**CR 501 WTP IRON FILTER IMPROVEMENTS
ADDENDUM NO.2**

DATE: June 5, 2024

Project Number: 142173320

KHA PROJECT 14217.3320	DATE MAY 2024	SCALE AS SHOWN	DESIGNED BY KHA	DRAWN BY RDC	CHECKED BY PHS	DATE	REVISIONS	DATE	BY
YARD PIPING PLAN									
CR 501 WTP IMPROVEMENTS PREPARED FOR CITY OF WILDWOOD FLORIDA									
SHEET NUMBER C-01

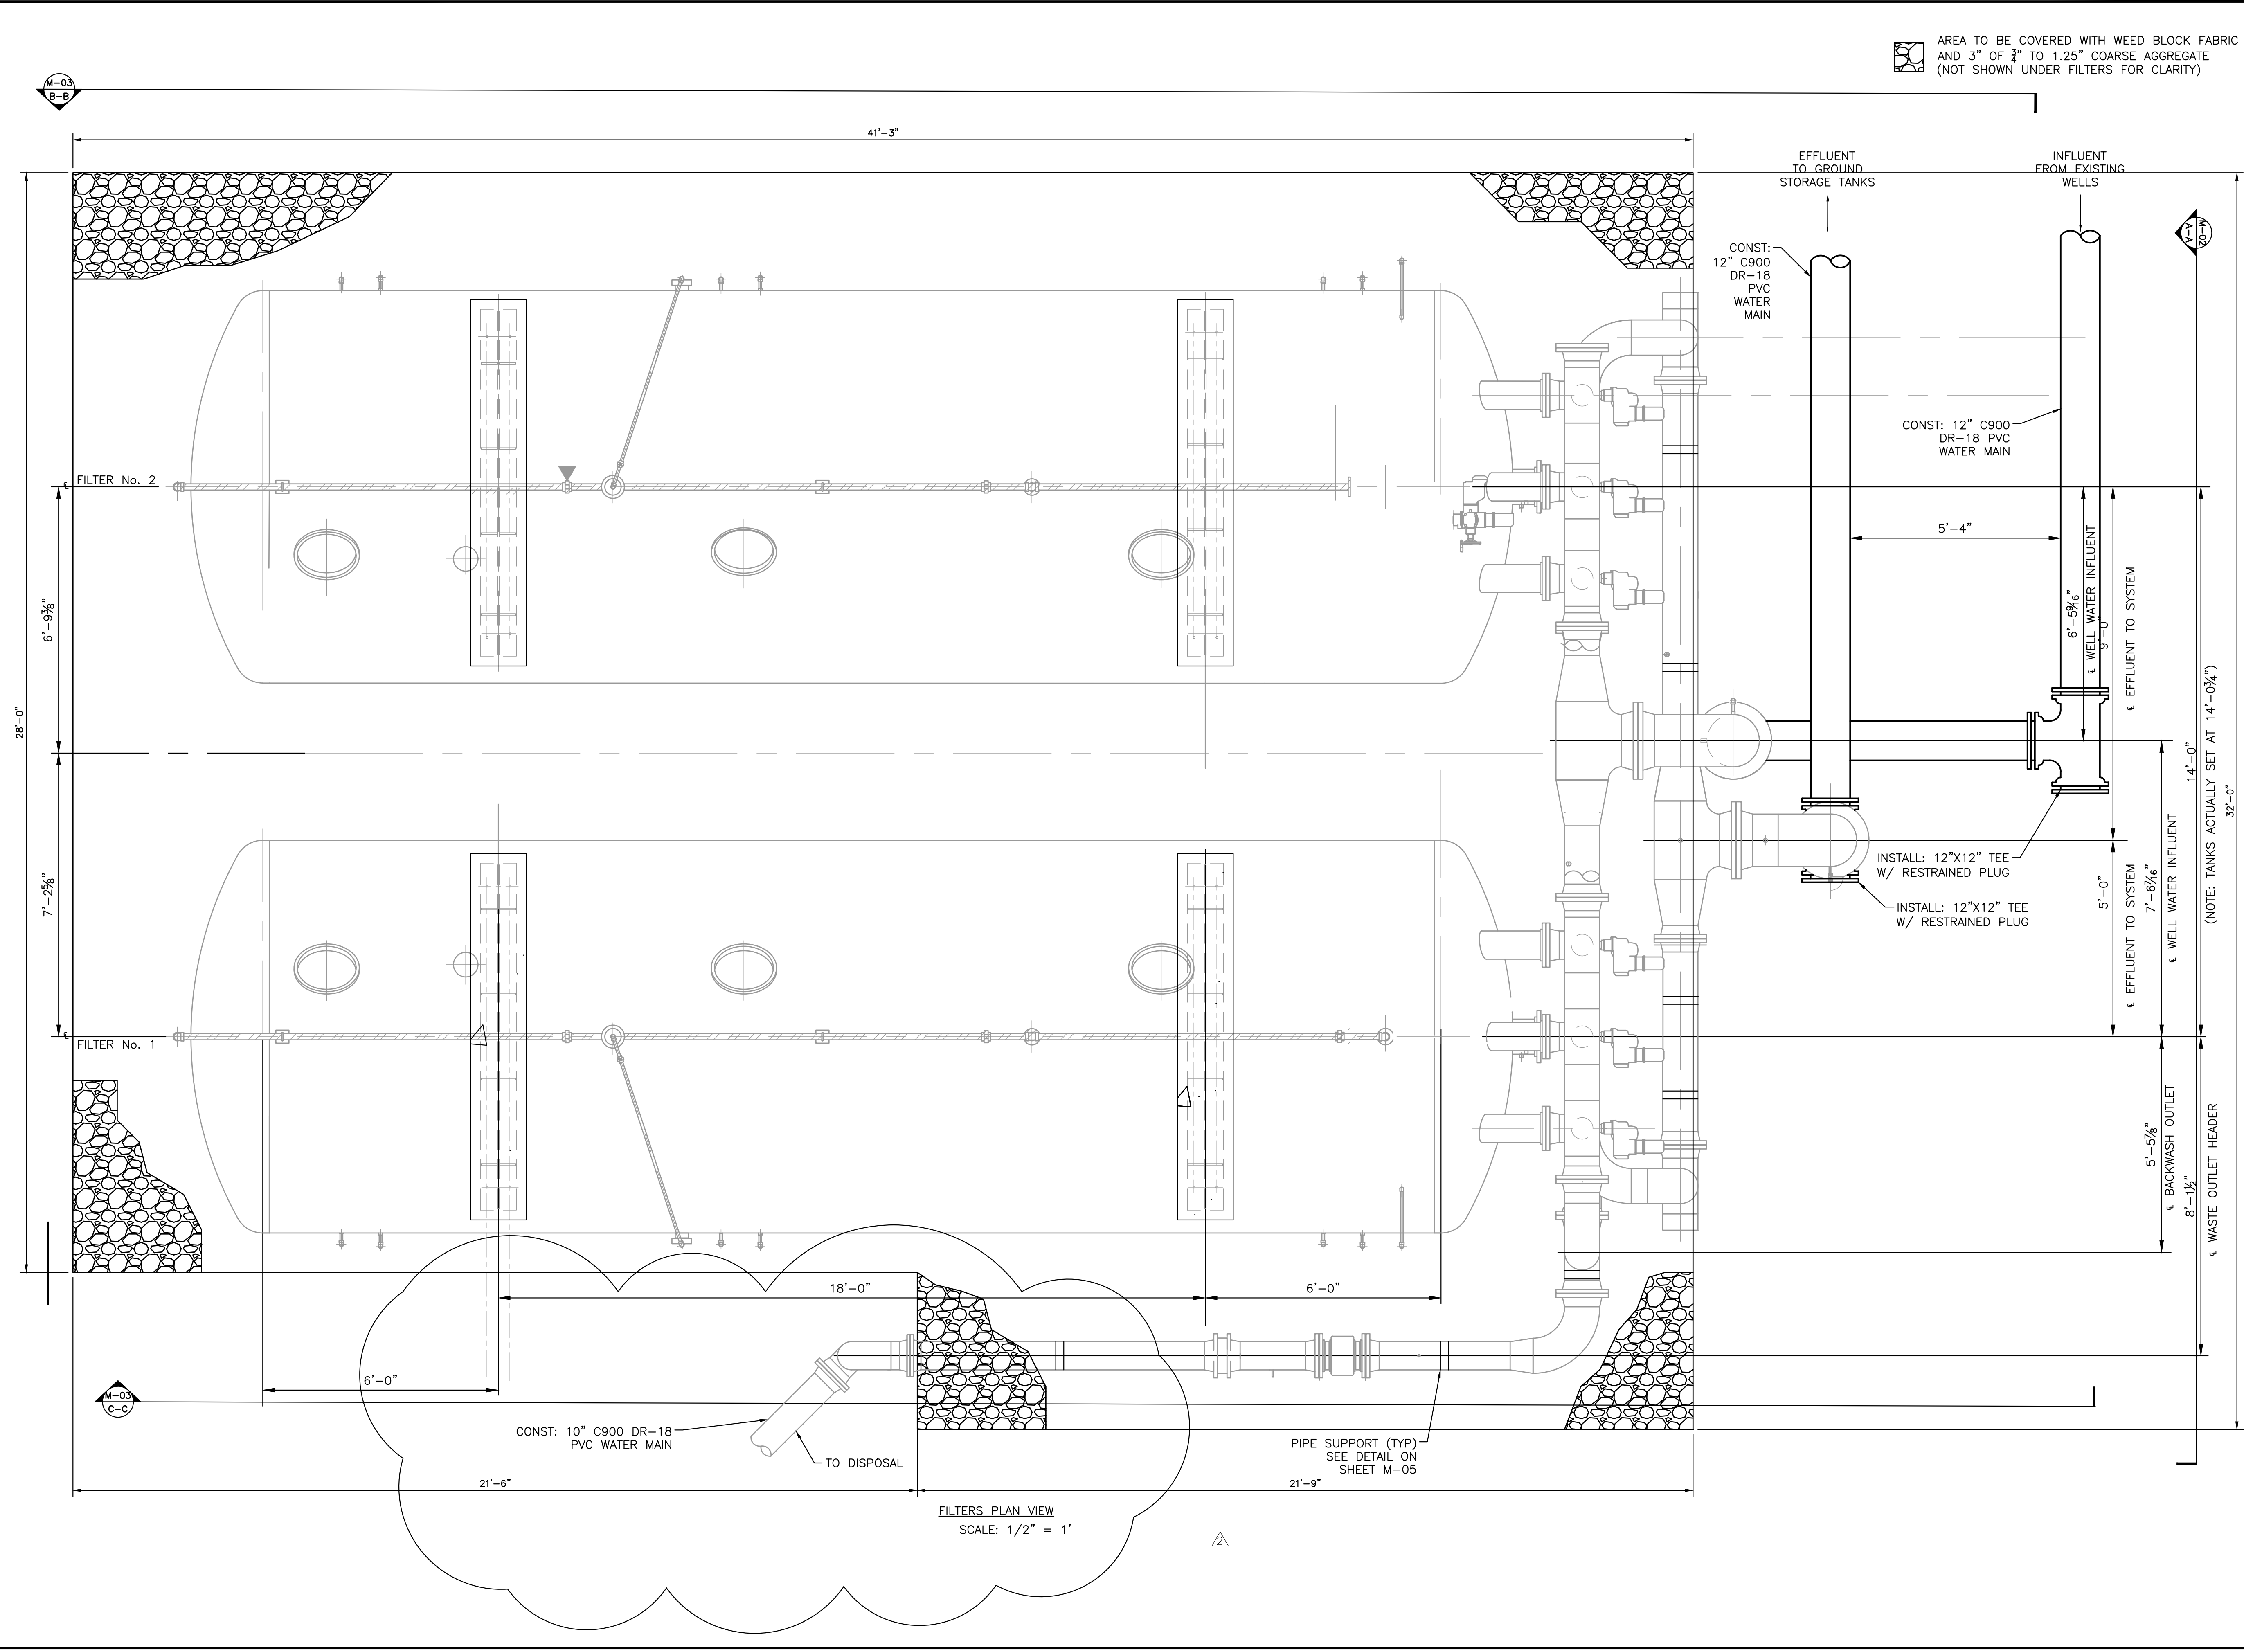
5. Drawing M-01 – M-03 does not match the site pipe drawing C-01 for the 10" Drainage line? Should we just relocate the 10" line where it ties into the drawings on M-01 - M-03? Also, what is depicted on the 10" drain line on the horizontal going to the pond? There is something drawn, but no callouts for what they are.

Response: Please see revised sheet C-01 and M-01 through M-03.
